# ACCELERATED DISTRIBUTION DEMONSTRATION SYSTEM

SUBJECT: Application for amends to Licenses DPR-58 & DPR-74, modifying  
 "Control Room Emergency Ventilation Sys" & associated bases.

Donald C. Cook Nuclear Plant Units 1 and 2  
Docket Nos. 50-315 and 50-316  
License Nos. DPR-58 and DPR-74  
CONTROL ROOM VENTILATION TECHNICAL SPECIFICATIONS

REASONS AND 10 CFR 50.92 ANALYSES FOR CHANGES TO THE  
DONALD C. COOK NUCLEAR PLANT UNIT NOS. 1 AND 2  
TECHNICAL SPECIFICATIONS

Figure 1

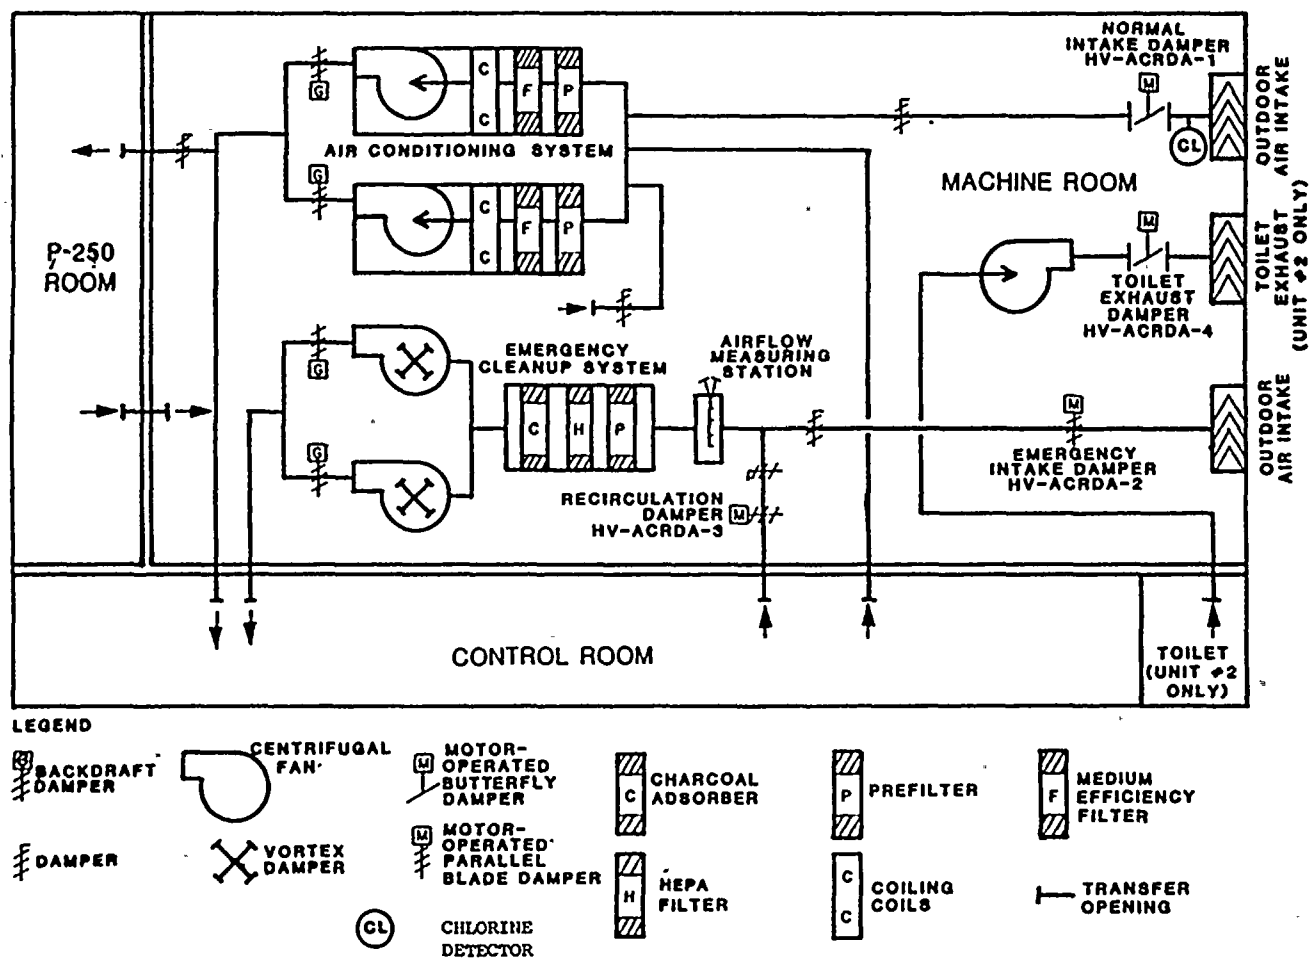
Figure 1 is a simplified flow diagram of the control room ventilation system. Figure 1 also shows the layout of the various rooms that are served by the control room ventilation systems. These rooms include the control room itself, the HVAC machine room (which houses the various ventilation equipment), and the P-250 computer room.

During normal operation of the control room HVAC system, outdoor air is drawn into the system through the normal intake damper. The HVAC system supplies air to the P-250 computer room and to the control room. Air from the

computer room flows to the machine room through a transfer grill. Air returns to the HVAC system from the control room and the machine room. The emergency intake damper and the toilet room exhaust damper are normally open. The recirculation damper will be maintained open in the future to provide protection against its failing to open if it should be closed.

In the event of a safety injection signal from either unit or a high radiation signal from the control room's area radiation monitor, the system would automatically be realigned in the recirculation/cleanup mode. In this mode, the normal intake damper and the toilet exhaust damper would automatically close to prevent unfiltered air from being drawn into the system. The recirculation damper would automatically open (if closed) to provide recirculation capability, and both pressurization fans would automatically start, drawing air through the filter unit. The operator would then turn off one of the redundant fans to ensure that air velocity through the filter unit will provide a minimum iodine residence time of approximately 0.25 seconds. The filter unit includes roughing filters, high efficiency particulate air (HEPA) filters and charcoal absorbers enclosed in a filter housing.

In the radiological mode, the system is designed to provide a flow rate through the filter unit of 6000 cfm  $\pm$  10%. This flow rate is a combination of air recirculated through the recirculation damper and drawn from the outside through the emergency intake damper. Pressurization of the control room envelope is provided by this outdoor air drawn by the pressurization fans. The design of the system is such that a minimum 1/16-inch water gauge (W.G.) pressure would be maintained in the control room. Since the computer room and equipment rooms would see little or no personnel ingress and egress under accident conditions, they are designed to provide a pressure greater than ambient, but potentially lower than the control room itself.
